REMARKS

ANNOTATED SHEET SHOWING CHANGES

ADDED Fig. 2

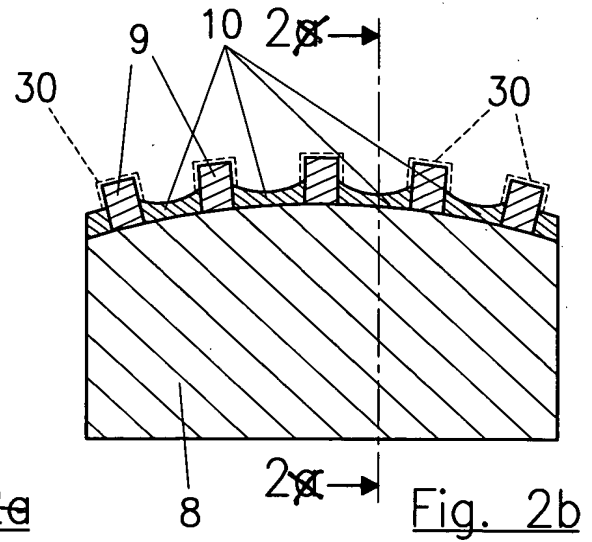
The drawings are objected to wherein the Examiner alleges newly added Figs. 2a and 2b are new matter. The drawings are amended to cancel Fig. 2a. Applicant traverses the objection to Fig. 2b which is explained more thoroughly below. Moreover, the drawings are amended to again include the originally-filed Fig. 2. Since Fig. 2 was filed with the originally-filed application, no new matter is added.

In response to the enablement rejection, Applicant submits with this response a Declaration by Ulrich Bingel, a person skilled in the art, pursuant to 37 C.F.R. §1.132. The Examiner first refers to the original-filed Fig. 2 and disclosure at pg. 6, Ins. 30-34 and states it would appear (presumably referring to Fig. 2) that the positioning of the plurality of optical elements (mirrors) on the basic body would prevent an intermediate layer from being formed between the basic body and the individual optical elements during the galvanoplastic joining technique (pg. 3 of paper no. 20040321). **Please note**, respectfully, the intermediate layer 10 is not formed in a stacked configuration with the basic body 8 and optical elements 9. That is, the optical elements 9 are on and “touch” the basic body 8 as clearly stated by the originally-filed application and explained by Ulrich Bingel (paras. (b)-(g) of the Declaration). Ulrich Bingel makes it clear that one skilled in the art would not interpret Fig. 2 and the disclosure at pg. 6, Ins. 30-34 in the manner presented by the Examiner, and

Please further note, Fig. 2 clearly illustrates basic body 8 and intermediate layer 10 as being hatched, that is, with **hatch lines** while optical elements 9 **are not** hatched. That is, the sectional view of Fig. 2 has the hatched portions of basic body 8 and intermediate layer 10 in the same plane of the page, while optical elements 9, since not being hatched, are illustrated **behind** the plane of the page. Accordingly, the originally-filed Fig. 2 clearly illustrates that basic body 8, intermediate layer 10 and optical elements 9 are not arranged in a stacked orientation, but are oriented, from the Fig. 2 view, with the intermediate layer 10 in front of the illustrated optical element 9. As Ulrich Bingel explains, one skilled in the art understands the arrangement from viewing Fig. 2. This arrangement is also shown in Fig. 2b as a side view of Fig. 2.

Moreover, the Examiner states it would appear (again presumably referring to Fig. 2) that the positioning of the plurality of optical elements (mirrors) on the

that one skilled in the art understands that intermediate layer 10 is on portions of basic body 8 between respective optical elements 9 (paras. (b)-(g) of the Declaration).

basic body would result in substantially covering all exterior surfaces of the optical elements during the galvanoplastic joining technique (pg. 3 of paper no. 20040321). As Ulrich Bingel explains, one skilled in the art knows how to avoid inadvertently covering optical elements by galvanic deposits (Declaration at para. (h)). Moreover, Applicant submits that it is well known and understood how to remove material from over a substrate, such as galvanic deposits over optical elements. This is further evidence that the claims are enabled.

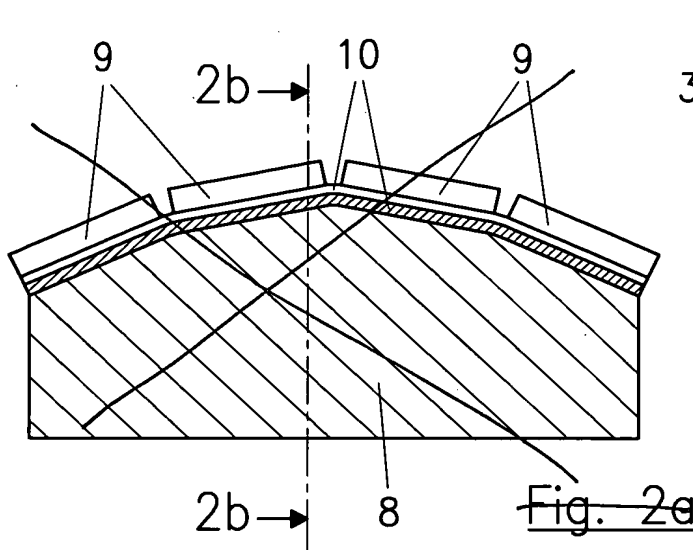
The amendment filed February 23, 2004 is objected to under 35 U.S.C. §132 for allegedly introducing new matter into the disclosure, particularly referring to the disclosure addressing previously added Figs. 2a and 2b. The disclosure directed to Fig. 2a is cancelled. Applicant traverses the objection to Fig. 2b which is explained more thoroughly below, and therefore, the disclosure to Fig. 2b remains.

Regarding Fig. 2b, Applicant submits such illustration is inherent from the originally-filed disclosure, including Fig. 2. Further evidence of the inherency of Fig. 2b with respect to Fig. 2 is demonstrated by the Declaration at, for example, para. (g). Applicant submits since Fig. 2b is inherent from the originally-filed application, the objection against Fig. 2b and the objection to portions of the specification directed to Fig. 2b are inappropriate and should be withdrawn.

Moreover, the objection to Fig. 2b is inappropriate since such figure is inherent from the originally-filed disclosure, including Fig. 2. Accordingly, the objection against Fig. 2b and the objection to portions of the specification directed to Fig. 2b are inappropriate and should be withdrawn.
